# Engineering Assessment Report

**RC245337**

<b>Applicant</b>	Deg Tegh Fateh Sikh Society Incorporated
<b>Application Description</b>	517 Hamptons Road
<b>Application Type</b>	« Appln Type Land use Appln Type »
<b>Valuation No.</b>	2352203207
<b>Date Sent To Engineers</b>	31 May 2024
<b>Return to Planning by</b>	10 June 2024
<b>Planner</b>	Tim Hegarty
<b>Transport Only?</b>	<input type="checkbox"/>

### **Separation between accessways/intersections**

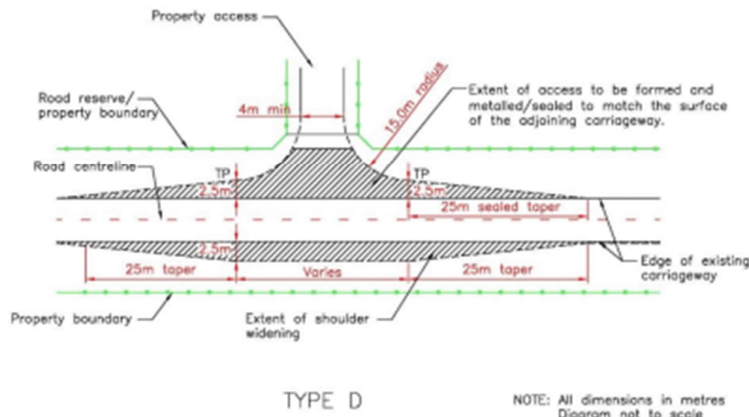
There is a non-conformance with the separation between accessways TRAN-TABLE6A - Accessway separation from other accessways. There would be also be a potential non conformance issue with the separation to the intersection if it moves to a position opposite the intersection as suggested by Abley. No significant concerns where the access design is appropriate. This may require minor widening of the shoulder depending on the outcome of any safety review of the final location. This could be addressed as part of safety reviews in an Engineering Acceptance process.

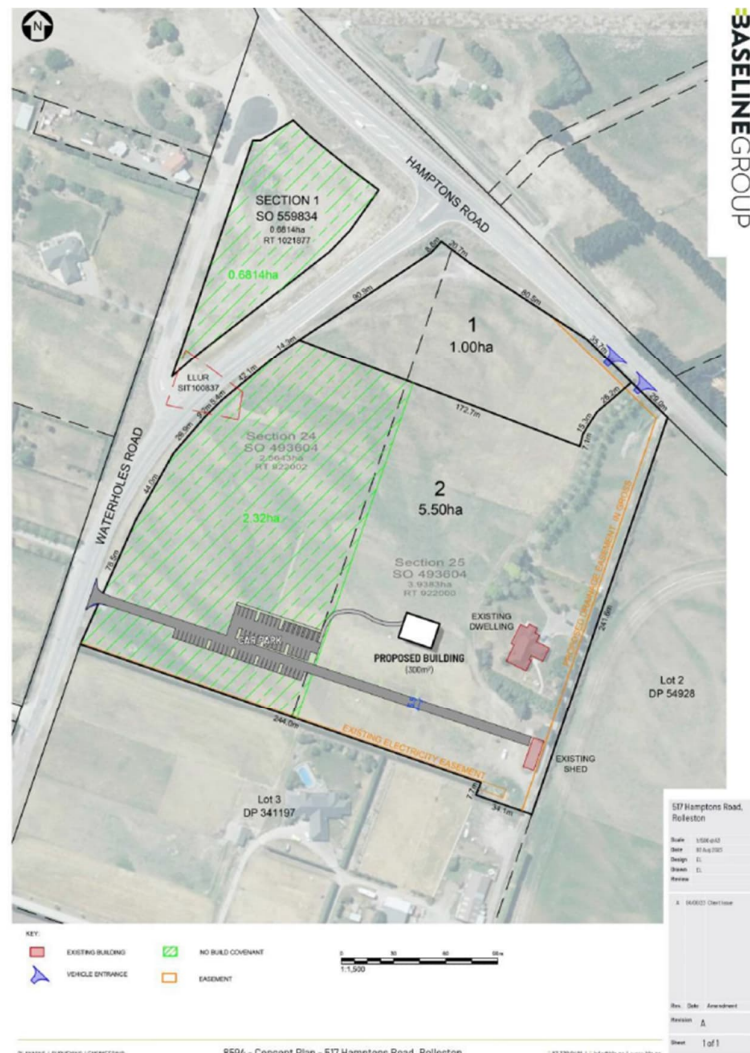
<p>The Paparua Water Race runs under each northern vehicle crossing on Hamptons Road, and alongside the eastern boundary of the site:</p>
---

Both crossings pass over the Water Race with a pipe culvert.

Added Advice Notes above. The proposed works are separated from water race.

There looks to be an easement in gross in place already.
